Title: Exchange Of Antenna Wire		
AG-SB-2025-02-B-EN	Effective Date: 25.07.2025	Compliance Category:
Applicability		A – MANDATORY B – RECOMMENDED C – OPTIONAL
Aircraft type & model: AutoGyro Calidus AutoGyro Cavalon	Affected Serial number(s): Depending on equipment see “Reason and Overview”	
The maintenance manual to be referenced is this stated or subsequent issue.		As per AutoGyro website
<p>This form is the response from AutoGyro GmbH either against a problem found in the product in service requiring a containment or rectification action, or as service information for aircraft modification incorporation. For help, contact airworthiness@auto-gyro.com.</p>

Reason and overview of the Service Bulletin (cause of problem if known)

Old version: (Black wire)

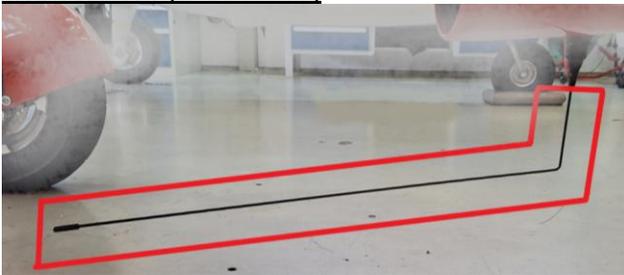
Continuous testing and optimization processes have shown that it may be advisable to replace the antenna wire on certain aircraft to achieve improved radio performance.

This affects aircraft factory-equipped with the item "49529 - Antenna with ballast" or if this part has been retro-fitted to other aircraft.

During the described replacement (see work instructions), the antenna wire supplied by the antenna manufacturer is replaced with an antenna wire manufactured by AutoGyro or locally made if equivalent quality can be assured. This new antenna wire has been geometrically improved to suit the AutoGyro-specific conditions, resulting in improved radio performance.

Improved type: (silver wire, if factory fitted)

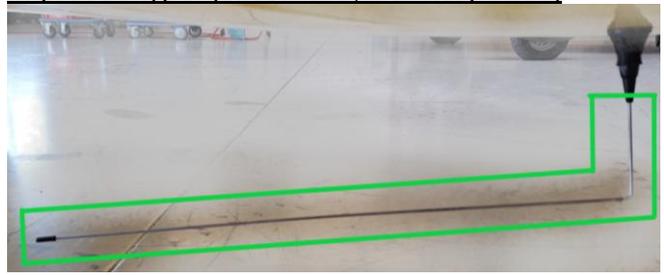
1. Remove controls cover (ref. JobCard 52-40-00 2-1)
2. Pictured is the affected antenna, which requires exchange of the antenna wire.

1. Remove cover below right-hand control stick (ref. JobCard 52-40-00 0-1)
2. Pictured is the affected antenna, which requires exchange of the antenna wire.

1. Loosen the grub screw of the antenna socket using a 1,5mm Allen Key. Do not unscrew completely.

2. Extract antenna wire, pull off rubber tip protection; keep rubber tip for re-using. Dispose of antenna wire.

<p>3. Attach rubber tip protection to new antenna wire.</p>	
<p>4. Put the replacement antenna wire in its socket. Tighten grub screw whilst keeping the antenna aligned with the aircraft's longitudinal axis. <u>NOTE: The head of the screw can be overtorqued easily!</u></p>	
<p>5. To ensure proper function of the fitted antenna, perform in-flight radio test. <u>ATTENTION: Improper installation of the antenna could lead to damage or destruction of the radio, for which AutoGyro cannot be held liable for!</u></p>
